ATTACHMENTS TO REPORTS OF THE BLAYNEY SHIRE COUNCIL MEETING HELD ON WEDNESDAY 18 DECEMBER 2024

02	BIC-17086 - Building Infromation Certificate Application
	for Modular Buildings and Building Alterations - 62 Osman
	Street, Blayney

Attachment 1: Survey Plan	1
Attachment 2: Drawings in Support of BIC	3
Attachment 3: Section J Energy Efficiency Assessment	15
Attachment 4: BCA Assessment Report	43
Attachment 5: Fire Engineering Report	75
Attachment 6: Peer Review	93
Attachment 7: Response to Peer Review	105
Attachment 8: Letter from Fire and Rescue NSW	115
Attachment 9: Acoustic Report	117
Attachment 10: Installation Certificate for Fire Rated Wall	129
Attachment 11: Certificate of Practical Completion	131
Attachment 12: Waterproofing Certificate for Wet Areas	133
Attachment 13: Structural Engineer's Certificate	135
Attachment 14: Certificate of Structural Sufficiency Design	139
Attachment 15: Transportable Building Certification	141
Attachment 16: Assessment of Snow Loading	165
Attachment 17: Statement on Disabled Access	169
Attachment 18: Development Application Drawings	173
Attachment 19: Rovest Holdings DA Submission Response	199

Figure 1 - Extract from the landscaping plan

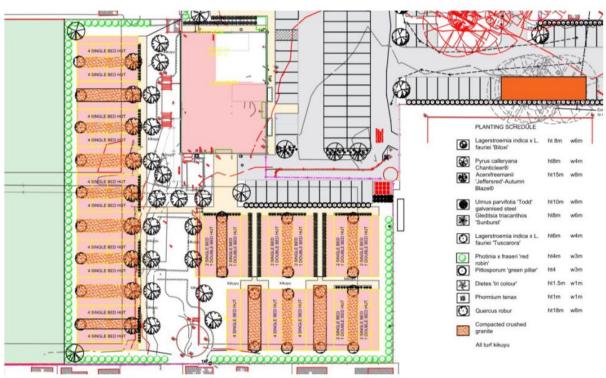
The landscaping plan (page 202 of the document provided) indicates that the space between the buildings is landscaped and not available for egress. The trees planted to the boundary have a height of 4m and a width of 3m, which indicates a pathway for egress between the units and the boundary also will not be available for egress.

Egress is therefore required by the covered walkway to each building.

It is noted that there are trees shown on the landscaping plan that are proposed to be planted between the buildings which are located on the left side of the plan as shown below. These trees should not be installed so that people can egress directly forward into the courtyard area to comply with the requirements of the Fire Engineering Report prepared by Credwell (Credwell FER). An updated landscaping plan can be submitted as part of the Development Consent application (for the future development on the property) to show these trees not being planted.

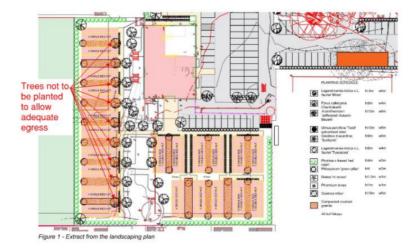
The Jensen Hughes Report states that as there are plants shown along side the egress paths that this will restrict egress for the occupants of the motel rooms. The Jensen Hughes Report also states that the travel distances from the motel rooms is up to 12.2m to egress to open space where it is stated within the Jensen Hughes report that the maximum travel distance is 6m. Under the requirements of Clause D2D5 of the BCA a class 3 building that is on the ground floor has a travel distance of up to 20m from a single exit (relevant parts of the extract of the clause shown below in yellow).

Photo 4: Rafter BMT

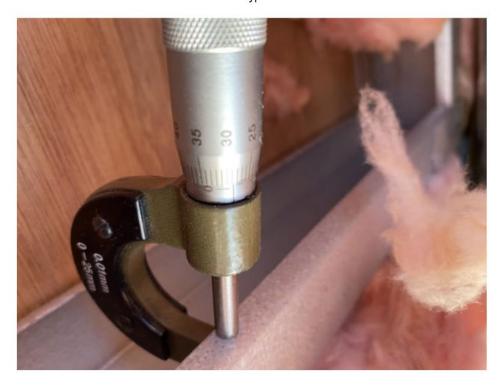
The photographs also show a ceiling insulation batt fitting within the rafter zone of 75mm which would typically indicate an R value of approximately 1.5 has been used. It is considered further investigation is required as to whether the insulation required by the JV3 has been achieved.

The roof is constructed of 75mm rafters and that the stated R4.0 insulation batts are between 190mm and 200mm in thickness. The following photographs which were taken on site by Bruce Johnston and Adam Goodsir in September 2023 show that the roof is 200mm thick and that the insulation is capable of complying with R4.0 as required by the J1V3 report.
